Sales ALERT Bulletin

DS1200-3 HANDLE CHANGE

Subject: DS1200-3 Handle Enhancement

Date: 2 December 2009

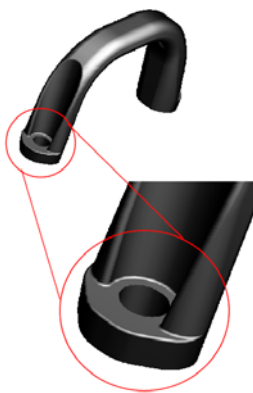
Please note the following change is a Design Enhancement Only and does not effect Form Fit or Function

The mounting scheme using the plastic handle with a Chamfered design for countersunk screw has been replaced with a non-Chamfered design using Pan Head screws. This new design reduces stress on the handle. See attached illustration below showing the difference.
